DRAINAGE AND TRANSPORTATION INFORMATION SHEET (REV 11/2018)

Project Title: PETROGLYPH PLUMBING **Building Permit #:** _____ **Hydrology File #:** G10D029
DRB#: _____ **EPC#:** _____ **Work Order#:** _____
Legal Description: TRACT 5A2-A1-4, VOLCANO BUSINESS PARK PHASE 2
City Address: 3031 PAINTED ROCK N.W.

Re: G10D029_TCL_CMMT

2 MOTORCYCLE PARKING DETAIL

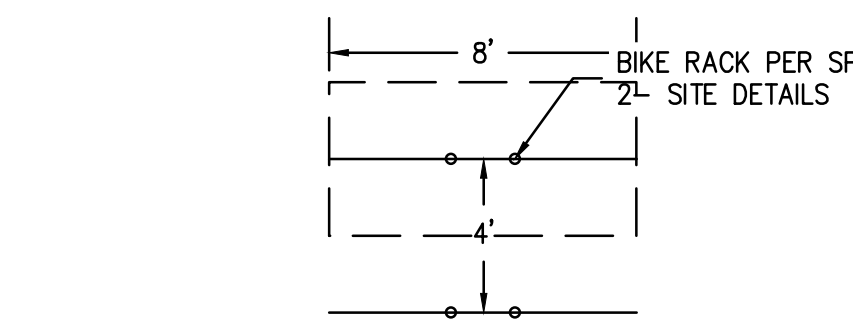
4. Motorcycle parking spaces shall be designated by its own conspicuously posted upright sign, either free-standing or wall mounted per the zoning code.
Added per detail

5. The pavement marking "MC" should be shown in the opposite direction for motorcycles entering the parking space.
Added
6. All bicycle racks shall be designed according to the following guidelines:

5 REFUSE ENCLOSURE
Scale: 1/4"=1'

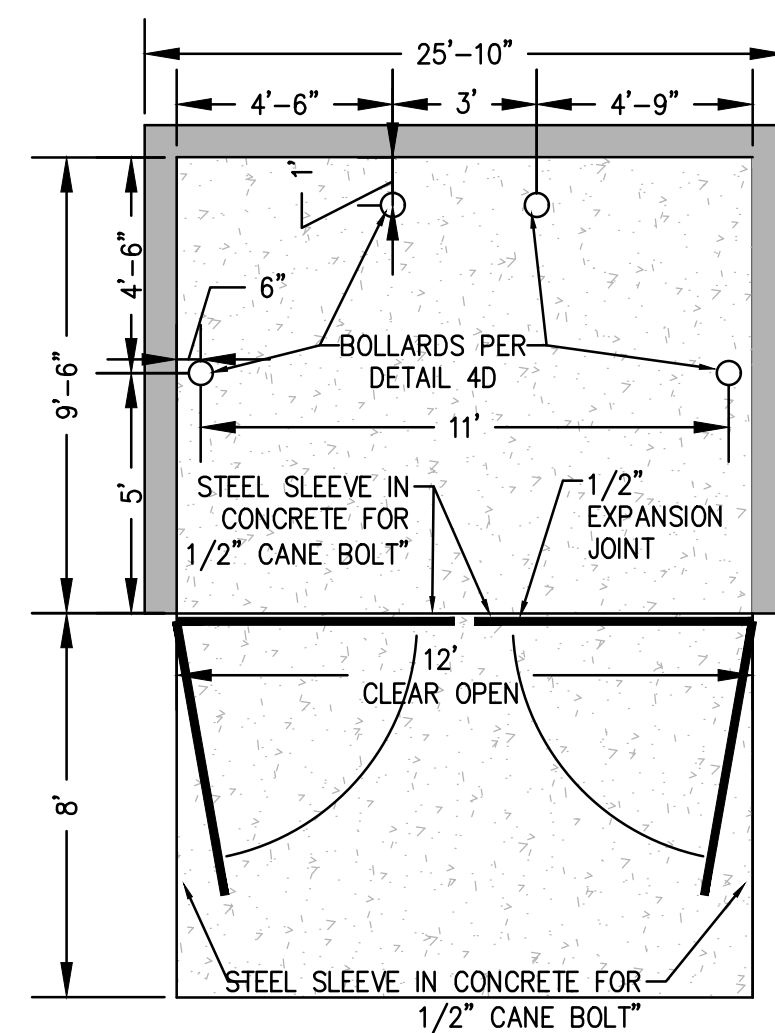
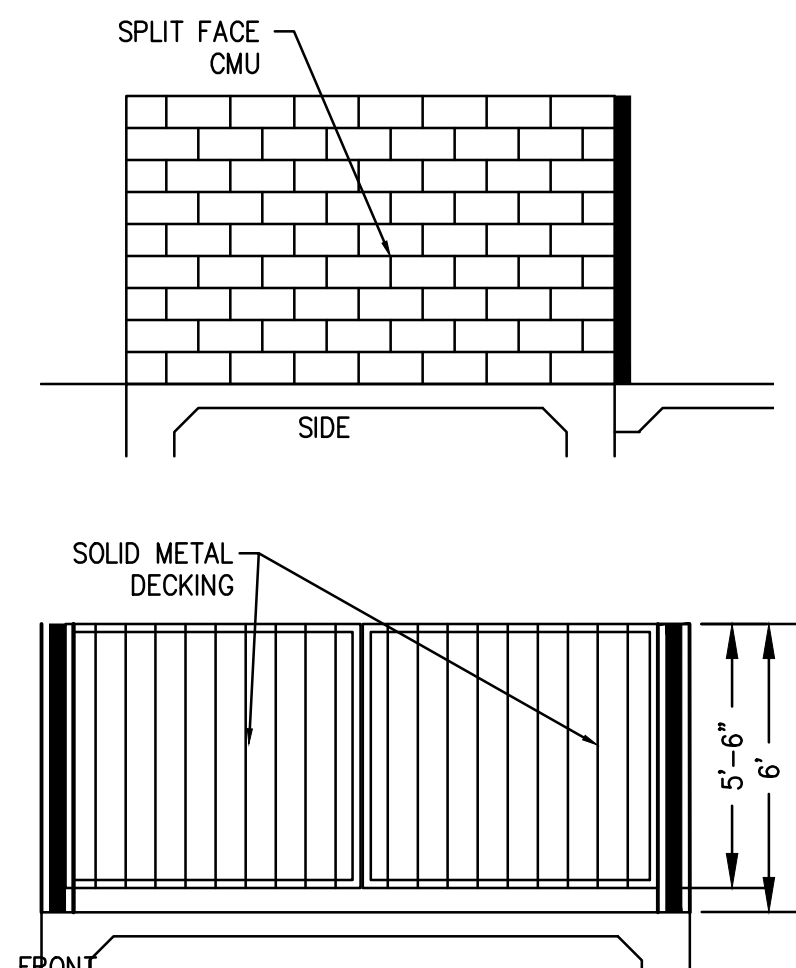
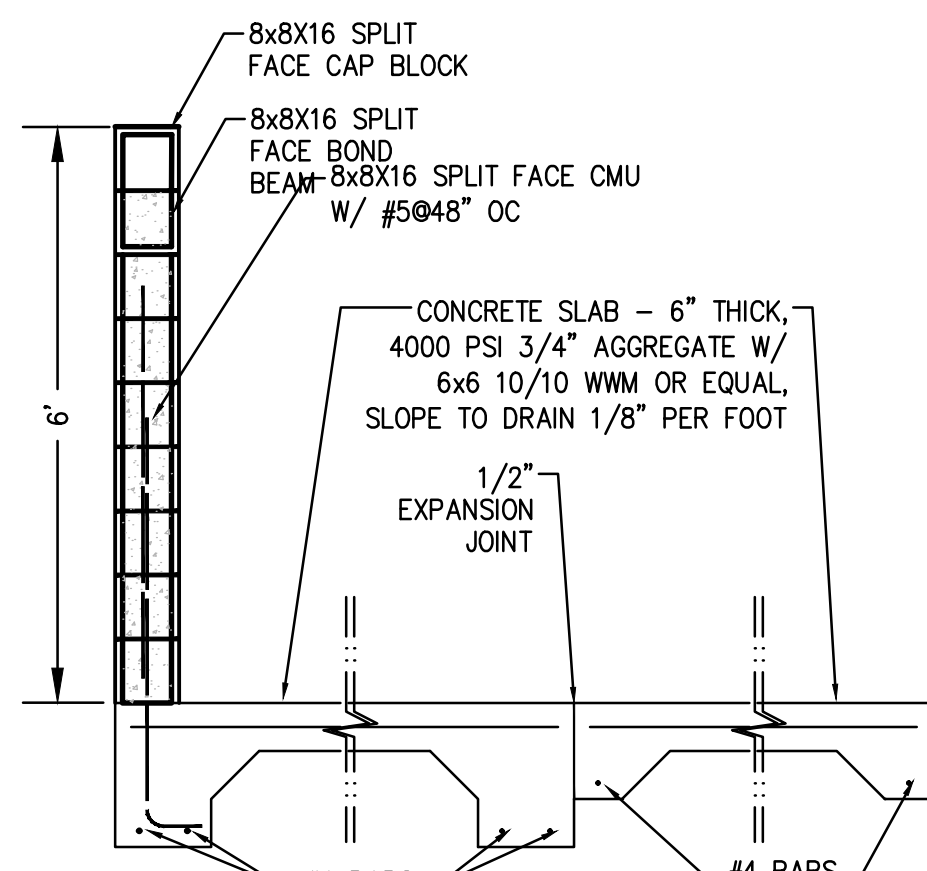
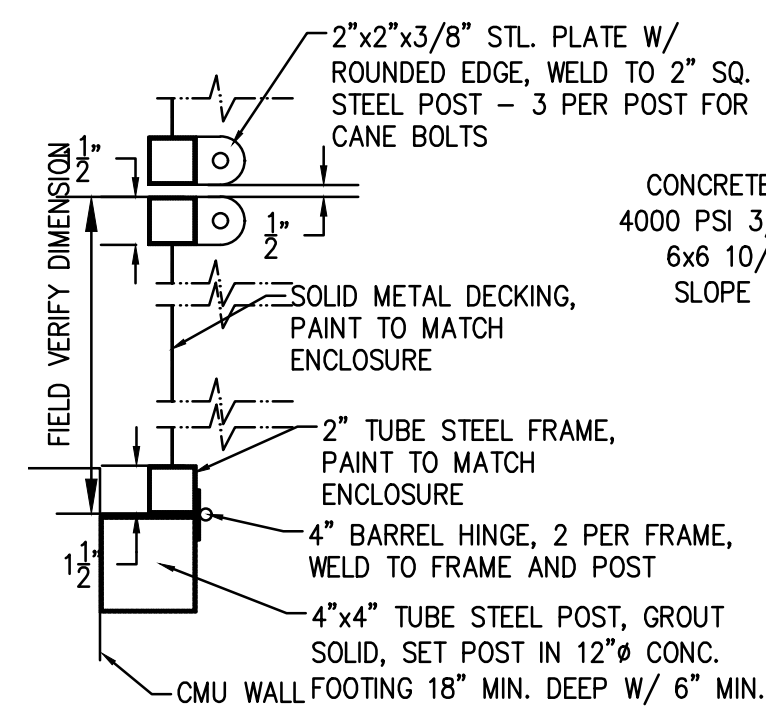
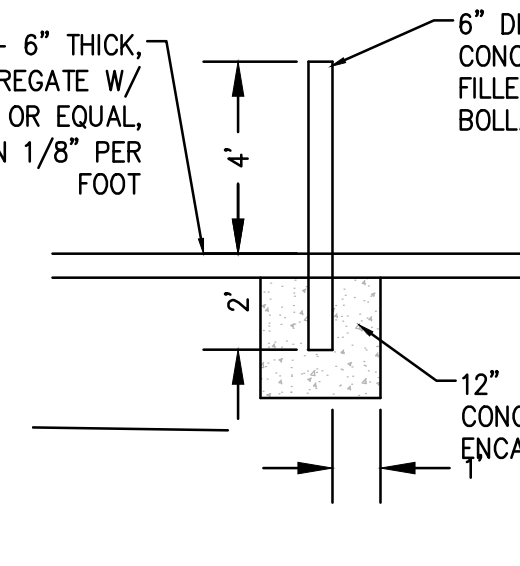
14. Refuse vehicle maneuvering shall be contained on-site. The refuse vehicle shall not back into the public right of way.; provide a copy of refuse approval.

Attached

7 ASPHALT SECTION
NTS

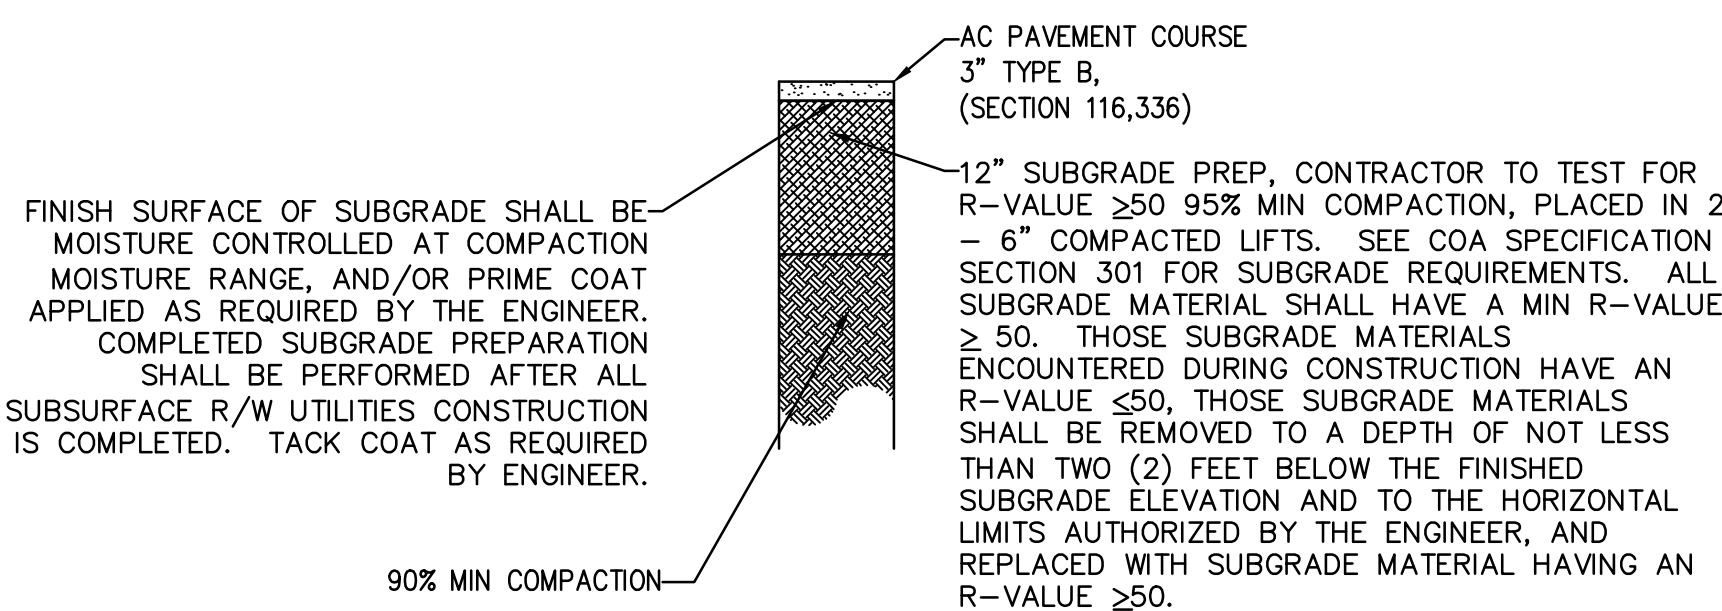
16. It is not apparent what type of pavement surface is being proposed. A hard driving surface will be required as part of this proposed project for parking area and drive aisles.

Key note reference

8 CURB DETAIL
Scale: 1"=1'

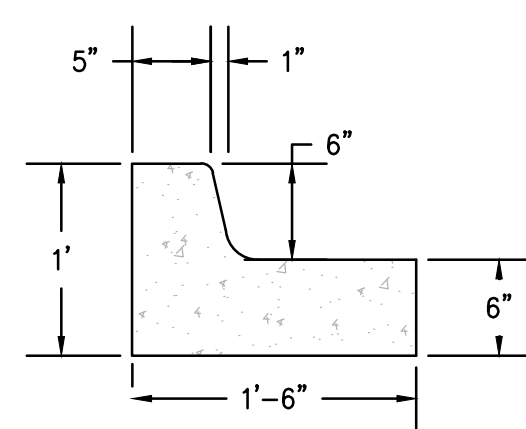
13. Curbing should be installed to delineate landscape, parking, and pedestrian ways and identify points of access. Please call out detail and location of barrier curb.

Key note reference

10 BIKE RACK DETAIL
Scale: NTS

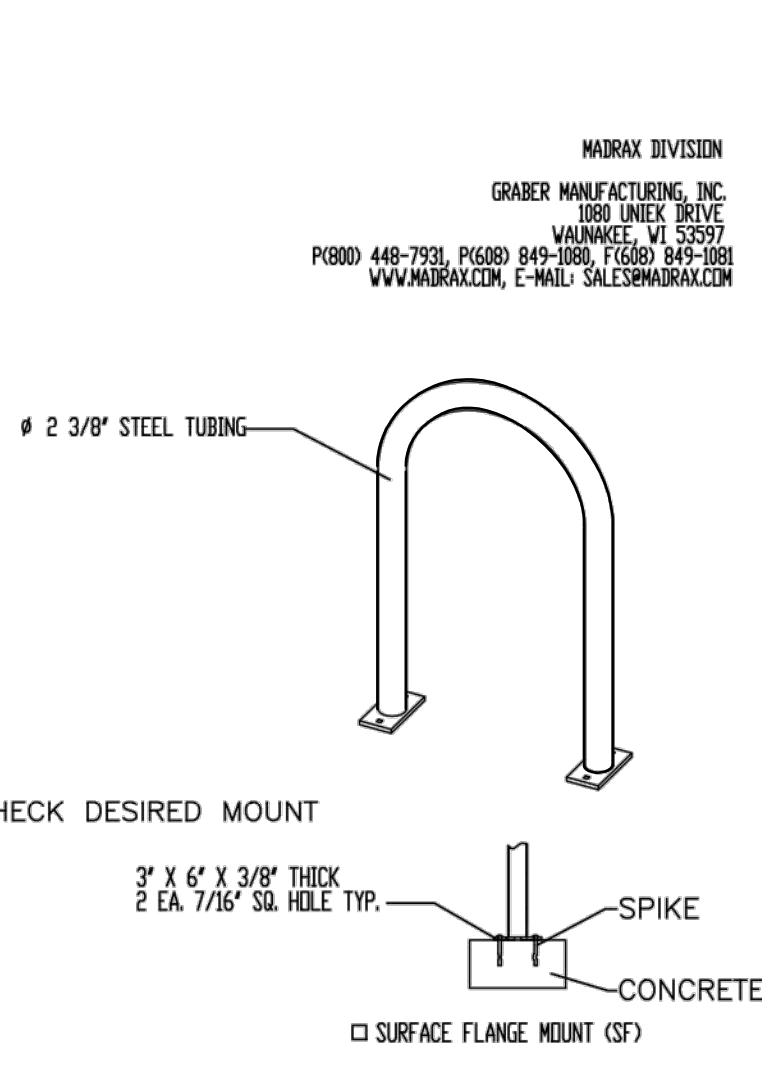
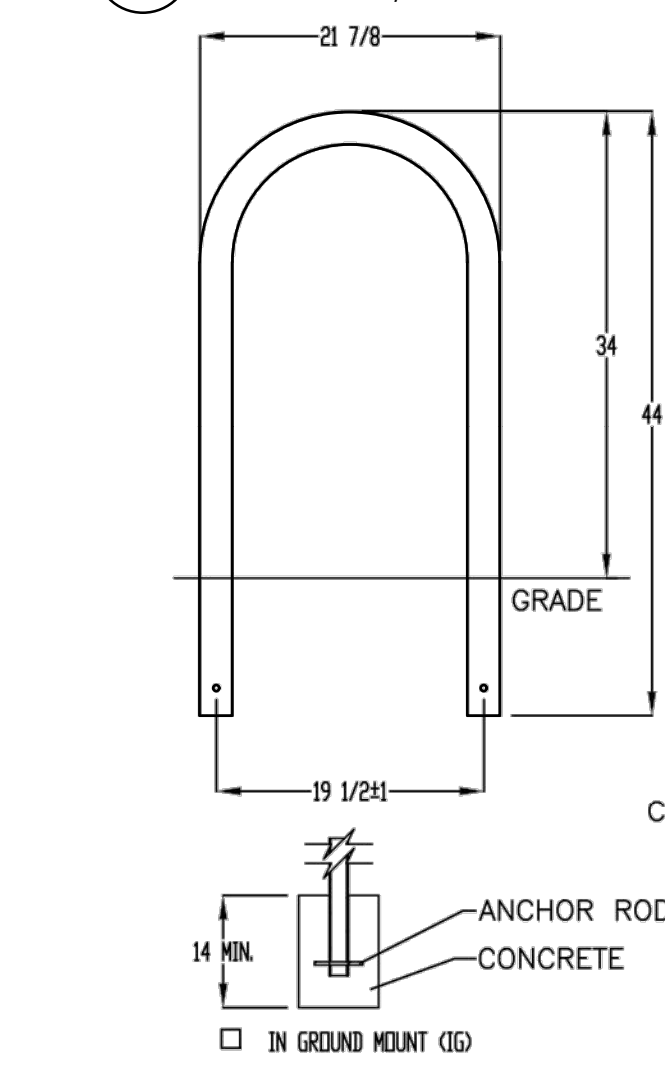
- a. The rack shall be a minimum 30 inches tall and 18 inches wide.
 - b. The bicycle frame shall be supported horizontally at two or more places.
Comb/toaster racks are not allowed.

- c. The rack shall be designed to support the bicycle in an upright position. See the IDO for additional information.
 - d. The rack allows varying bicycle frame sizes and styles to be attached.

- e. The user is not required to lift the bicycle onto the bicycle rack.
 - f. Each bicycle parking space is accessible without moving another bicycle.
Bicycle shown and detailed

7. Bicycle racks shall be sturdy and anchored to a concrete pad.
Bicycle shown and detailed
8. A 1-foot clear zone around the bicycle parking stall shall be provided.
Bicycle shown and detailed

9. Bicycle parking spaces shall be at least 6 feet long and 2 feet wide.
Bicycle shown and detailed
10. Per the IDO, a 6 ft. wide ADA accessible pedestrian pathway is required from the public sidewalk to the building entrances. Please clearly show this pathway and provide details.
Key note reference
